Development Special Use Permit #2020-0001
Encroachment #2020-0002
Transportation Management Plan SUP #2020-0006
1200 North Henry Street Amendment

Purpose of Application
Consideration of an amendment request for a Development Special Use Permit with site plan and modifications to construct a multifamily residential building with ground-floor daycare and retail, amending DSUP #2017-00020.
Special Use Permits and Modifications Requested:
<ol style="list-style-type: none"> 1. A development special use permit with site plan and modifications to construct a multifamily residential building with ground-floor daycare and retail. This includes Special Use Permits for an increase in the floor area ratio up to 2.5 and for an increase in density and height for the provision of affordable housing pursuant to Section 7-700 of the Zoning Ordinance. Also, there are modifications to the open space requirements and the required height to setback on North Fayette Street 2. An encroachment request of a canopy into the public right of way for N Fayette St; and 3. A Transportation Management Plan Special Use Permit for Tier 2 (multi-family building).

Staff Recommendation: APPROVAL WITH CONDITIONS
Staf

Figure 1 – Original Approved Building Height Diagram

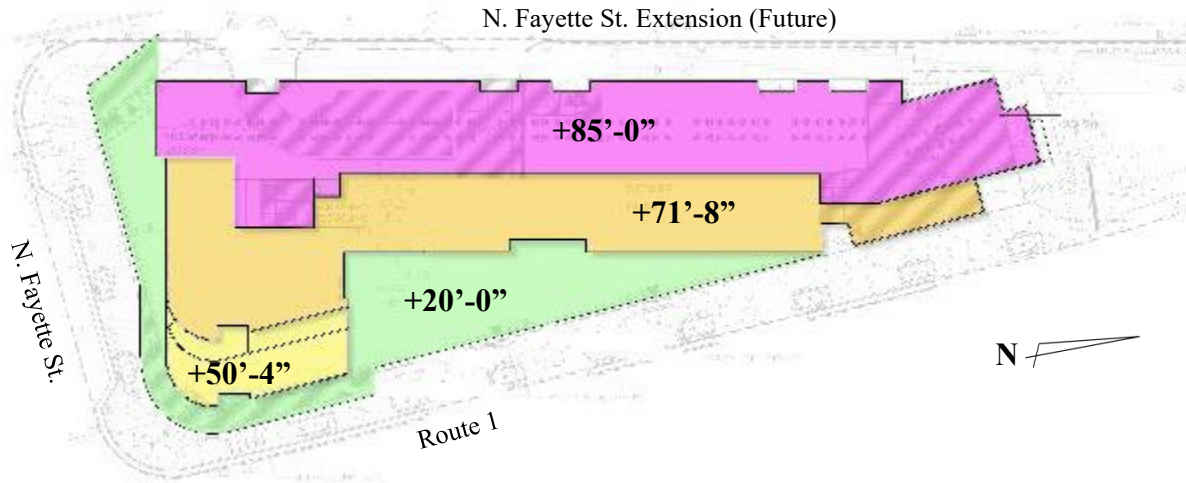
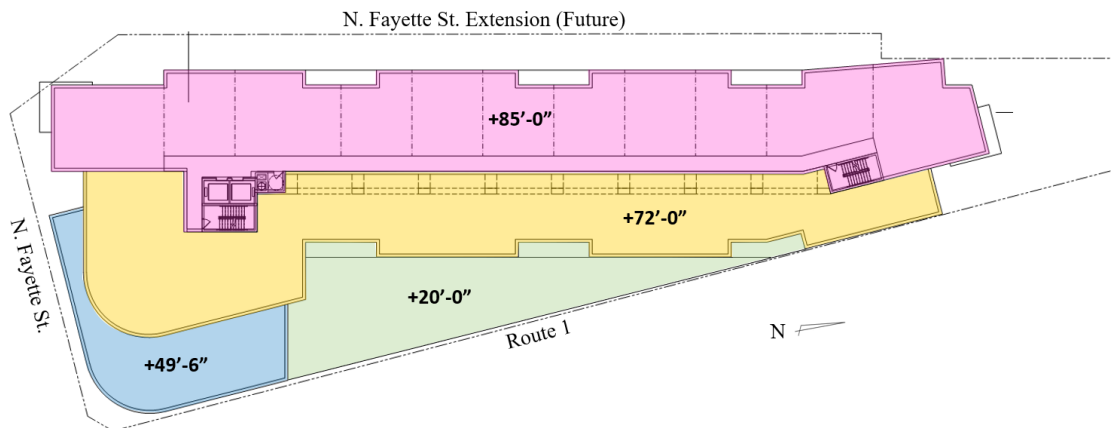
The building has a triangular footprint reflecting the triangular block form, and the building elements and step backs further emphasize this. The west edge of the building follows the future N. Fayette Street extension with an 85-foot high “bar” that spans the majority of the site from north to south. The building height then steps down to the east, measuring approximately 72 feet above grade with an “L” shaped form. Further, a third element, with a pronounced curving corner, steps down to approximately 50 feet. The lowest portion of the building fronts Route 1, measuring 20 feet above grade, and is occupied by retail and the daycare. A rooftop amenity terrace is proposed above this element. The diagrams below (Figure 1 and Figure 2) illustrate the original building footprint and heights and the proposed revised footprint and heights.

Original Approved Site Plan - DSUP#2017-0020

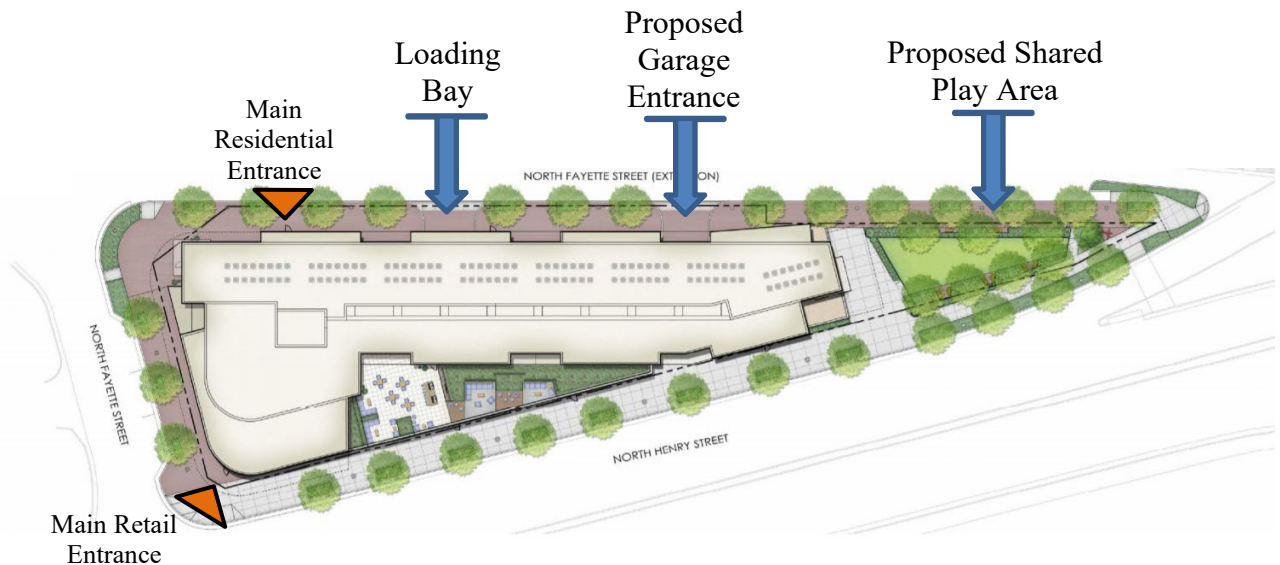
Proposed Site Plan – DSUP #2020-0001
